FIGURE 1.—407 AIRSPEED LIMITATIONS—KNOTS—IAS
[AD 99-06-15]

(7) This AD revises the limitations section of BHTC Model 407 RFM by replacing sheet 1 of Figure 1-3 in the RFM with Figure 1 of this AD, revising sheet 3 of Figure 1-5 of the RFM, and adding an operational limitation for allowable yaw trim and directional control input.

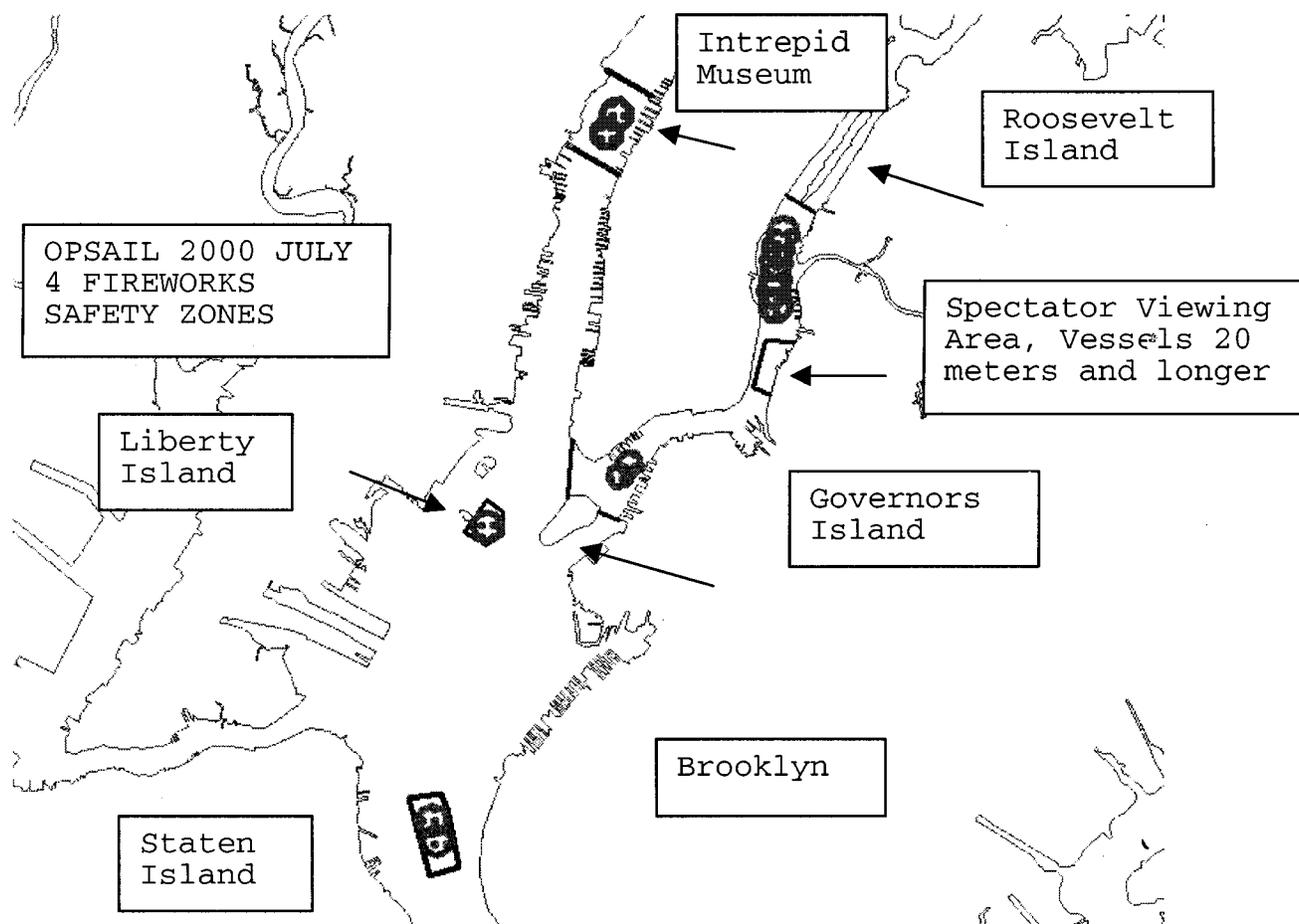
(4) Install a redline at a Vne of 100 KIAS on all airspeed indicators. Remove or obscure any previously installed lines or arcs above 100 KIAS. If the redline is installed on the instrument glass, also install a slippage mark on the glass and on the instrument case.

(6) Mark the airspeed limitations placard in Figure 1-3 in the RFM to indicate that it has been superseded by this AD, and insert a copy of this AD into the RFM. Also, mark the airspeed indicator in Figure 1-5 of the RFM to indicate a Vne of 100 KIAS.
